ENVIRONMENTAL REVIEW TEAM REPORT
ON
ARROWHEAD RIDGE
COVENTRY, CONNECTICUT
NOVEMBER, 1975

Project CPA-CT-01-00-1037

ENVIRONMENTAL REVIEW TEAM REPORT
ON
ARROWHEAD RIDGE
COVENTRY, CONNECTICUT

SOIL MAP

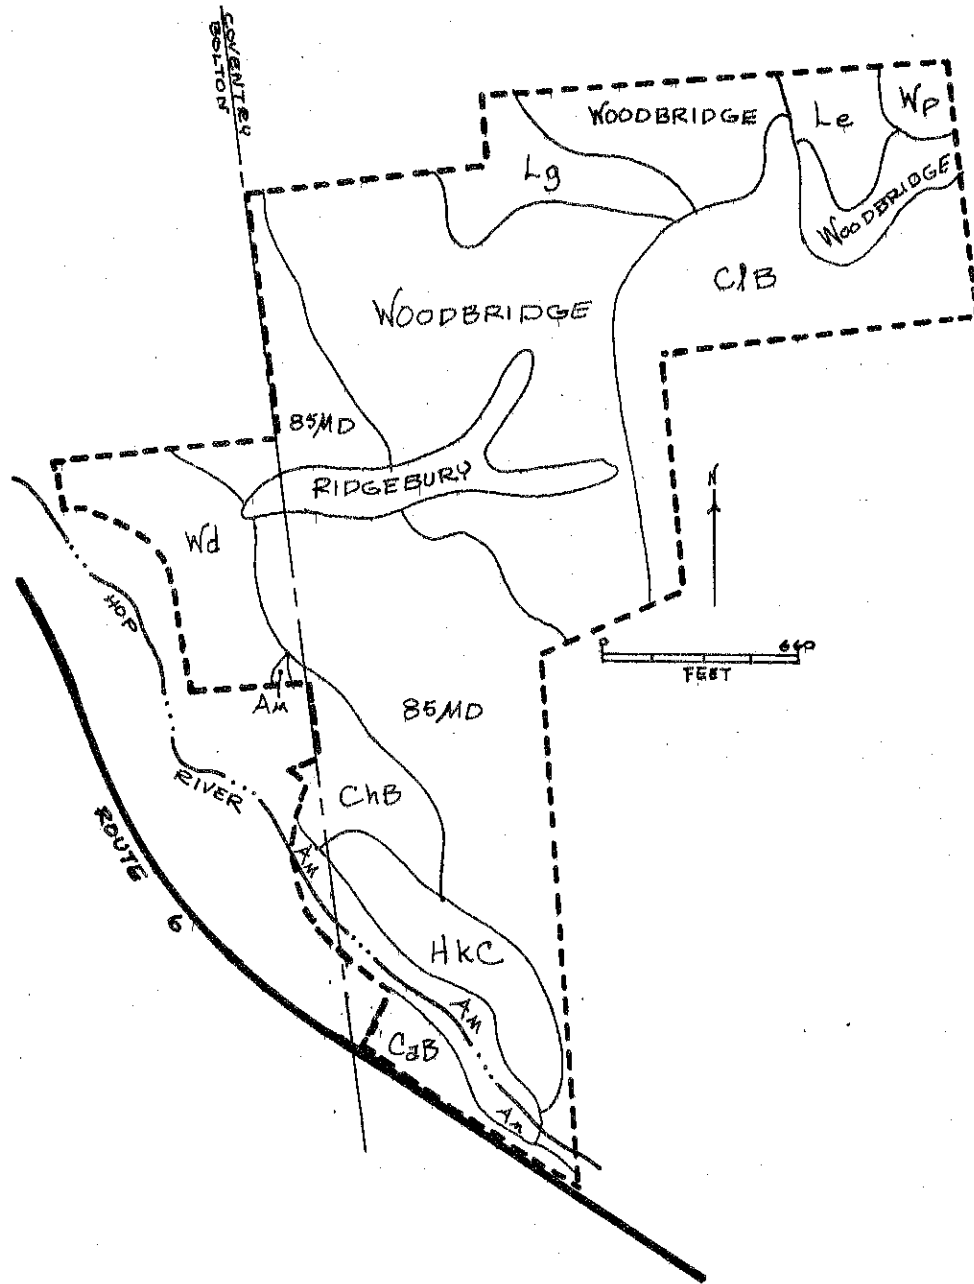
A large portion of the site contains a deep to hardpan layer which may be restrictive to water (or waste) movement. Referred to as a Montauk 85MD soil type on the soil map, this area possesses steep slopes ranging from 15-35%. An extremely stony, fine sandy loam, this soil has a hardpan (compact layer) located about 40" below the surface which may cause water to move rapidly downslope over the surface of the hardpan especially during the wet season.

Permiability above the hardpan is moderate but the pan drastically reduces percolation. Sewage disposal problems may arise during the wet season when the pan restricts the downward movement of excess water in the soil. In those times, excess rain water, that from spring thaws, or septage effluent from the leach fields may move rapidly downslope over the surface of the pan. Since the leach field galleries for the development complex are planned over this soil area, it will be important to locate the leaching galleries in sufficient soil or fill depths so that the effluents can be successfully eliminated without an environmental or health hazard.

In general, the site does appear to have soils suitable for sewage disposal in the area proposed for the leaching field galleries. However, the steep slopes and length of transmission lines leading to this area may create installation and operational problems. The steep slopes may create serious erosion and sediment problems both during and after construction. Detailed plans for controlling water runoff and soil erosion should be prepared and followed. The Erosion and Sediment Control Handbook for Connecticut is useful in preparing this plan, and the District Conservationist of Tolland County is available to assist the developer in the plan preparation as well.

A considerable ledgy, or shallow to bedrock soil area exists in the northeast corner of the site, underlaying an area where some of the residential units are planned. This soil, the Charlton-Hollis complex C1B, is a rocky, fine sandy loam with slopes ranging from 3-15%. The soil is underlain by bedrock usually less than 20 inches below the soil surface. Bedrock outcrops, in addition to the generally shallow and rocky soil condition, may cause severe problems and considerable expense when excavating for construction. As noted in the soils limitations chart, limitations for urban development in this soil type will vary from slight to severe as within this soil type, there can be pockets of deep soil, which, if located using a means such as a backhoe, can provide acceptable locations for residential units and on-site waste disposal systems.
